SUSPENSION AND  
DAMPERS.

No. H-2

TO: ALL ROOTES GROUP DEALERS  
MODEL: SUNBEAM TIGER, (260),  
SUBJECT: PANHARD ROD BRACKET FAILURE

**FIG. 3**

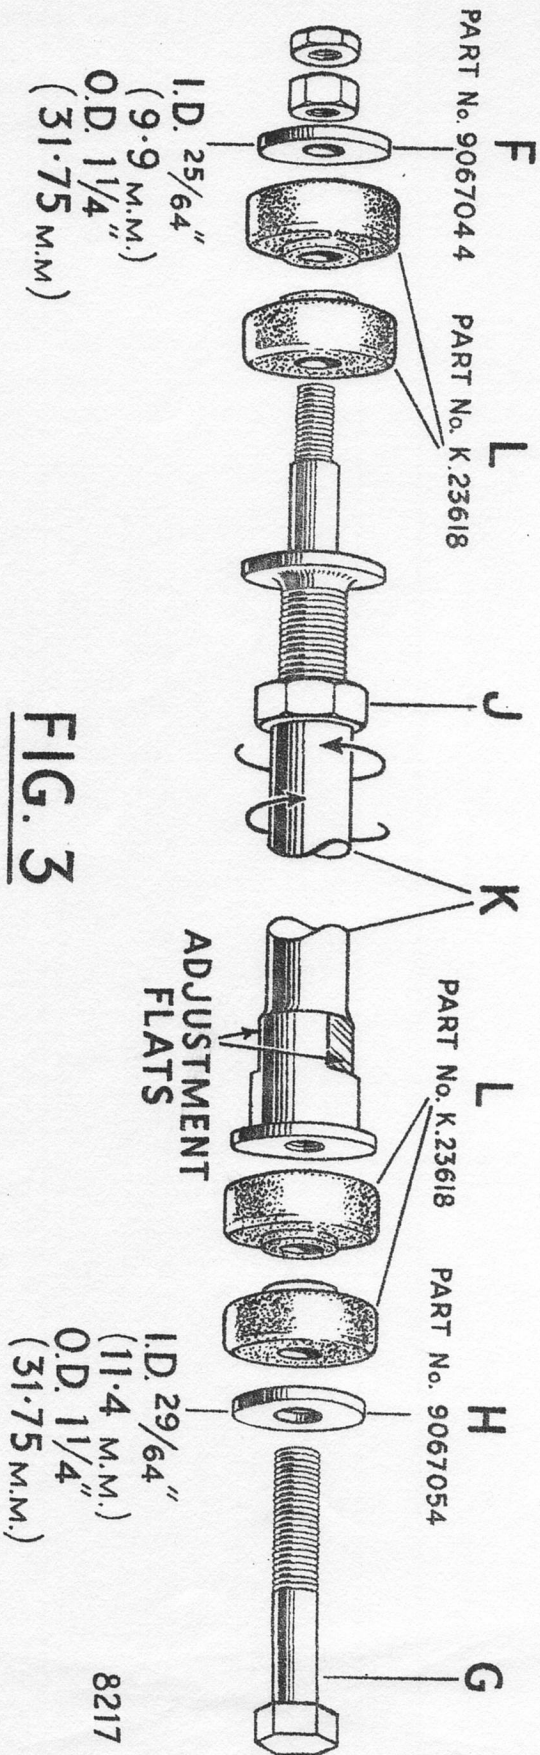
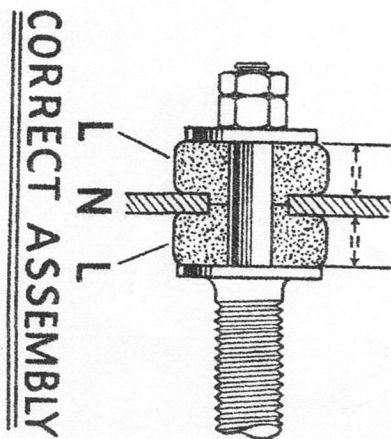
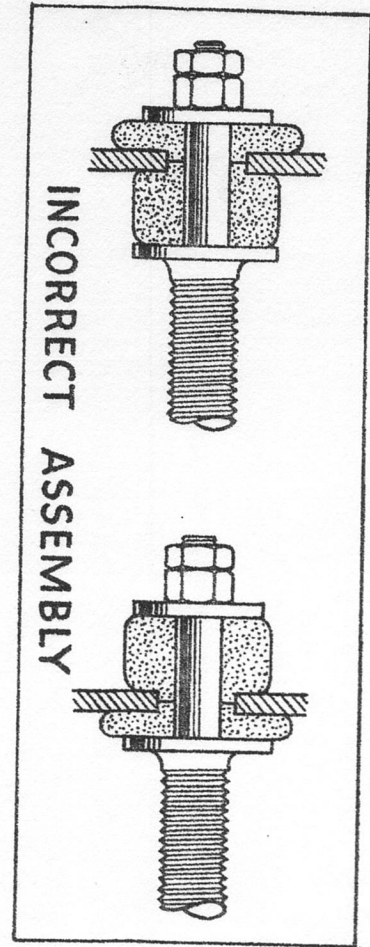
In order to minimise the possibility of Panhard Rod Bracket failure on the above model, all cars prior to Chassis Number B.9473544 should be checked at the next Service call to ensure that the correct washer, Part Number 9067044, is fitted at the chassis frame end of the Panhard Rod as shown on the attached illustration.

Both locknuts 'M' should be removed together with the plain washer 'F'. The internal diameter of this washer 'F' should be 25/64" (2.9 mm.); if greater, the washer must be replaced with Part Number 9067044, and the old washer discarded.

The new washer should be fitted, both locknuts retightened and the Panhard Rod adjusted as follows:-

1. Load vehicle with 165 lbs. (75 kgs.) in the boot, 20" (50 cms.) rearwards on the centre line of the rear axle.
2. Slacken locknut 'J' and adjust Panhard Rod tube 'K' by turning it clockwise or anti-clockwise until the rubber bushes 'L' mounted on either side of the Panhard Rod bracket 'N' are of equal thickness, i.e., when there is no tension or compression in the rod, as shown.
3. Tighten Panhard rod locknut 'J' and remove weights from vehicle.
